# SERVICE INFORMATION

## NO. SI 42-247

Garmin Service Bulletin No. 22117 Rev. B

NO.: 22117 Rev B

**Figure 1 - 233-00075-01 and 233-00075-02 Cable Retention Pins**

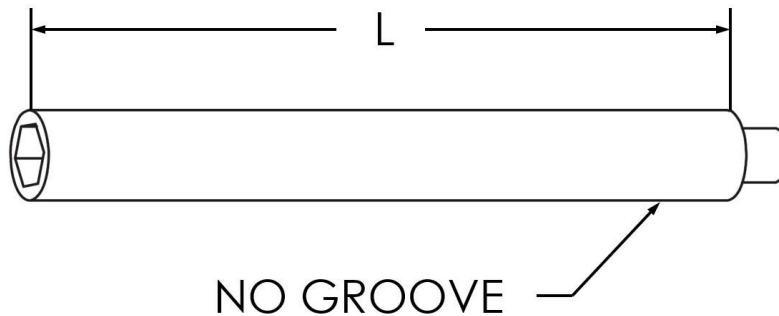
Both the -01 and -02 Cable Retention Pins have no grooves (See Figure 1). The -01 Cable Retention Pin is 1.48" long and the -02 is 1.60" long (See Figure 1).

This Service Bulletin contains instructions to replace the cable retention pins with new longer cable retention pins to ensure the GSM servo gearbox capstan is free to rotate in the event that the clutch retaining bolt is not retained.

233-00075-03 and 233-00075-04 Cable Retention Pins

**Figure 4 - New Cable Retention Pins**

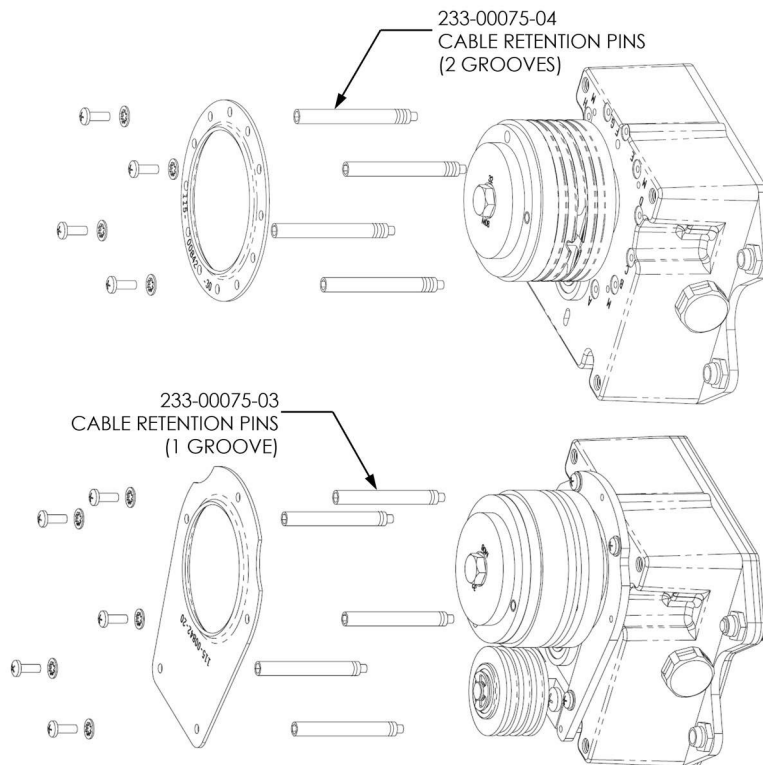
1. Refer to the applicable airframe specific maintenance manual to gain access to the GSM 86.
2. Gain access to the cable guard pins by removing cable guard hardware including screws, washers, and top ring.
3. Replace each cable retention pin with a new part number as listed in Table 1.

<b>New Pin P/N</b>	<b>Replaces Pin P/N</b>
233-00075-03 (one groove)	233-00075-01 (1.48")
233-00075-04 (two grooves)	233-00075-02 (1.60")

4. Make sure the same hole locations are used as the existing cable guard pins and torque to 6-8 in-lbs.
5. Install the removed cable guard hardware and torque screws to 6-8 in-lbs.
